Response to EPRA's invite to comment on the proposed WACA Design Guidelines

Bicycle Transportation Alliance (BTA) would like to provide a public comment on EPRA's proposed WACA Design Guidelines.

FIGURE 14 – BICYCLE PATHS AROUND THE PERIMETER OF THE GROUND

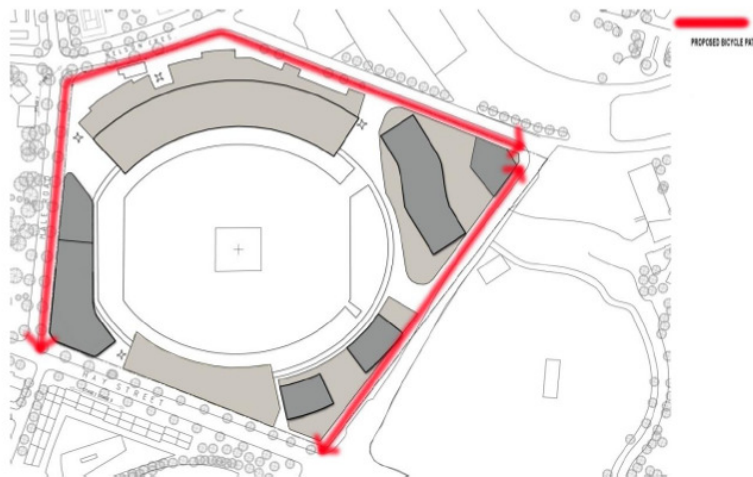
The sections requiring clarification relates to the proposed bicycle path around the perimeter of the ground (Figure 14, Page 26):

1) *Amount of pedestrian traffic on event days*

Event days do result in additional pedestrian traffic to allow for the crowds to gain access to the grounds. Will traffic management plans be required to ensure that pedestrian flow over the dedicated bicycle paths are kept to a minimum, to allow for cycling traffic to continue? As a poor example of traffic management at a sporting venue, visit the shared path on an event day where it is difficult to cycle on the shared path due to the number of pedestrians failing to keep left on the shared path next to Subiaco Oval.

3) Continuation of the cycle path and lack of bicycle path on Hay St

Figure 14 (page 26) does not show a cycle path on Hay St. Currently there is a shared path, and bicycle lanes on Hay St. Why have these not been included in Figure 14?

The BTA recommends that WACA guidelines are updated to address the above concerns.

FIGURE 13 – INDICATIVE VEHICULAR ACCESS POINTS

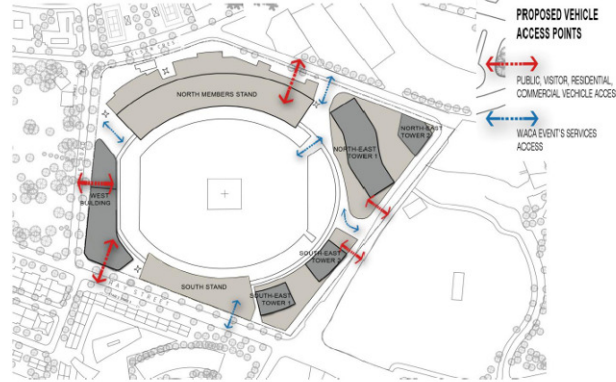
2) Vehicle access into the buildings/ground

Figure 13 (page 25) shows several accesses into the grounds/buildings, which will cross over the dedicated bicycle path. Will appropriate signs be installed to advise that cyclists have rights of way on the bicycle path, and to ensure that motor vehicles do not block the cycle path when entering/exiting the ground/buildings?
